CITY GATE REBUILD JSP26-01

Consideration at the request of Consumers Energy for approval of the Preliminary Site Plan and Stormwater Management Plan. The subject property is located at 44488 Grand River Avenue and consists of approximately 1.09 acres, situated north of Grand River Avenue and west of Novi Road (Section 15). The property is zoned I-2 (General Industrial). The applicant proposes to demolish and replace the existing regulator building, components, and piping.

Subject: Novi-Wixom City Gate Rebuild Preliminary Site Plan Review Response Letter
Sidock Group Job No. 25278.A

SITE GENERAL NOTES

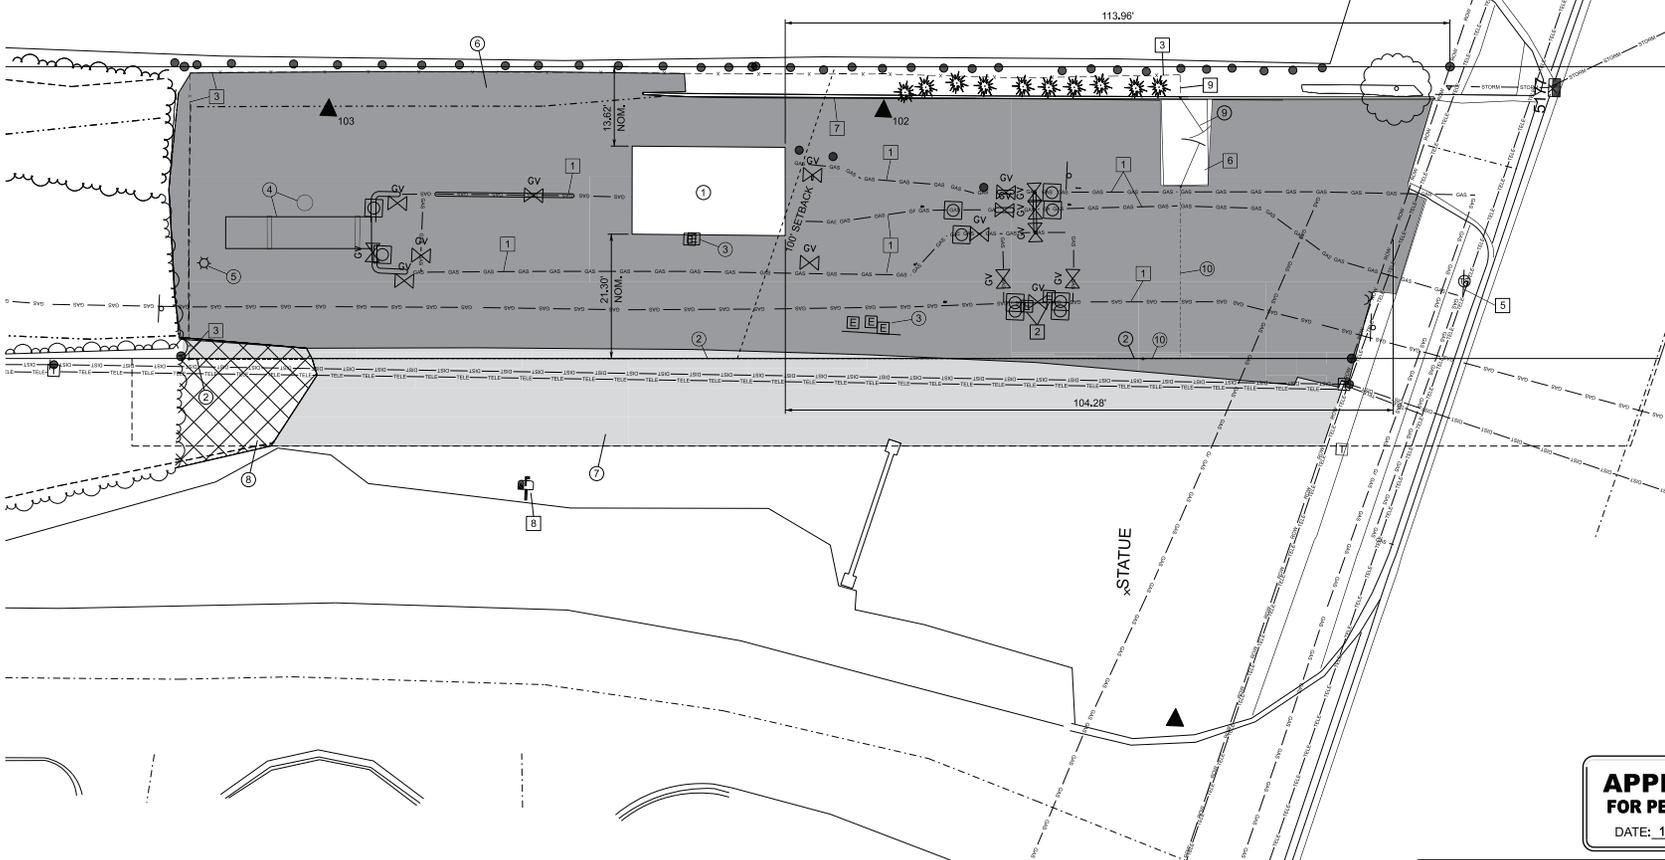
Review Comment 3: “Site plan notes on sheet 2 indicate site visits weekly, the narrative provided indicates monthly, please verify”

Response 3: Employees may visit the site on a weekly basis.

GEO-SPATIAL & GAS ASSET MANAGEMENT Gas Meter and Regulation Department	PROJECT ID: _____ STA. NO.: _____ FIELD AREA: NORTHVILLE-WEST WAYNE	DRAWING NO.: _____ SHEET: 11
	NOV- WIXOM CITY GATE 2026 CONSTRUCTION REGULATION BUILDING EXTERIOR ELEVATIONS	N-4 C-1616-VEN

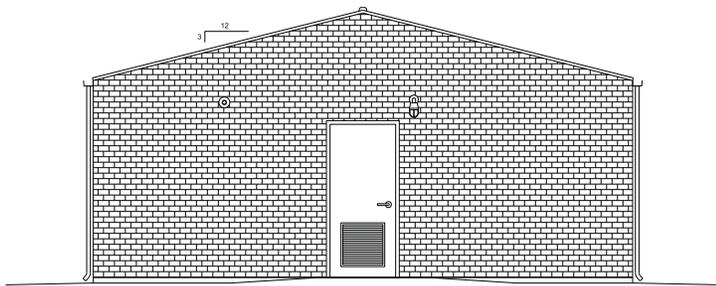
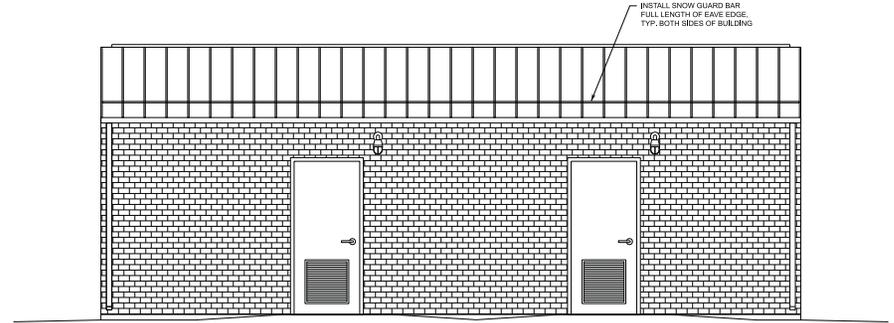
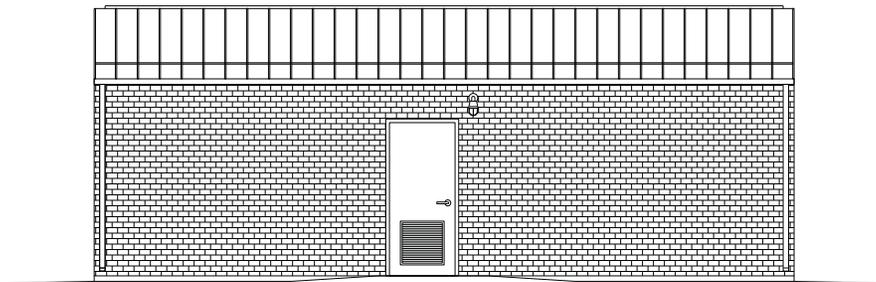
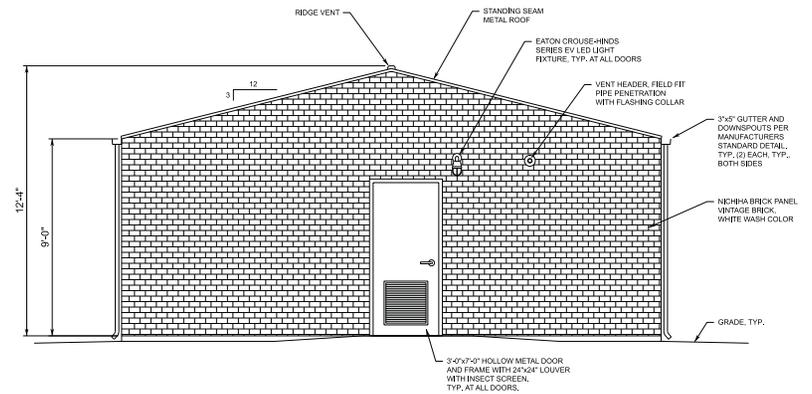
3. Section 9 Façade under Section 5.15.9 for underage of brick and overage of fiber cement architectural panels with simulated brick on the north and south elevations (25% allowed, 100% proposed) and the east and west elevations (25% allowed, 60% proposed) due to the utility nature of the building, which is hereby granted;

9 Façade Waiver is required. **The Section 9 Façade Waiver will be subject to review and approval by the Planning Commission. The waiver is supported contingent on an approved sample board.**

Response 1: Consumers Energy is requesting a Section 9 Façade Waiver for the overage of patterned siding.
